MODIFICATION RECOMMENDED

N5245A-04

N5245A PNA Series Microwave Network Analyzers

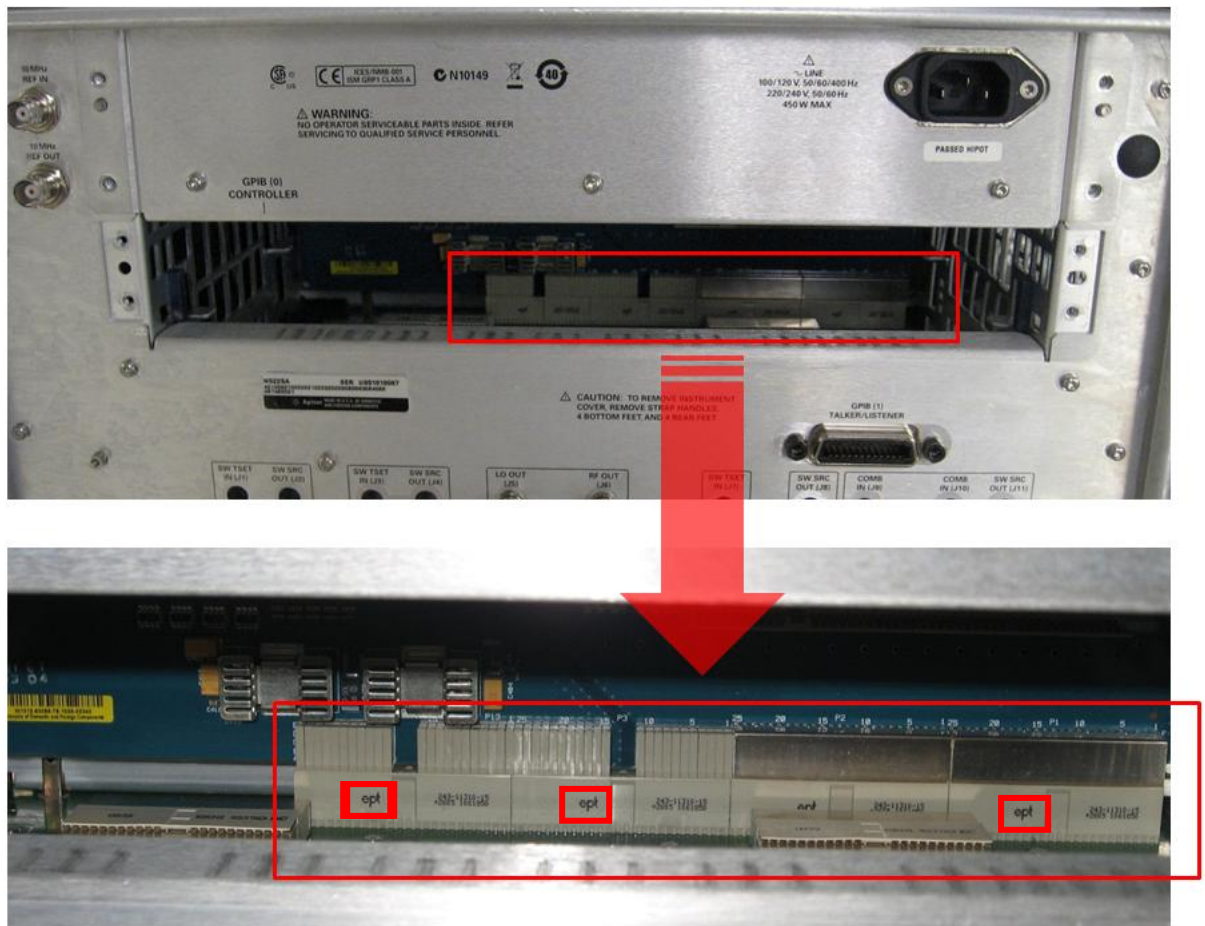
1. Remove the CPU assembly from the analyzer's rear panel. Refer to the PNA Service Guide chapter 7 section titled, "Removing and Replacing the CPU Board Assembly" for removal and reinstallation procedures. To view the online Service Guide, see the numbered list on the next page for instructions.
2. As per the photo below, inspect the system motherboard connector to see if it has one or more "ept" logos.

3. If the connector has one or more “ept” logos, return the analyzer to Agilent for replacement of the system motherboard. If the connector does not have one or more “ept” logos, email support_ctd-soco_support@agilent.com, providing the analyzer model and serial number and details of the malfunction symptoms.

4. *For Agilent Service Technicians only:* Only new boards without “ept” logos should be installed. Before installing the new board, look to see if it has one or more “ept” logos. If so, email support_ctd-soco_support@agilent.com, providing the analyzer model and serial number. Wait for further instructions in an email reply. New boards without “ept” logos can be installed.
For installation instructions, refer to the PNA Service Guide chapter 7 section titled, “Removing and Replacing the System Motherboard.” To view the online Service Guide, see the numbered list on the next page for instructions.
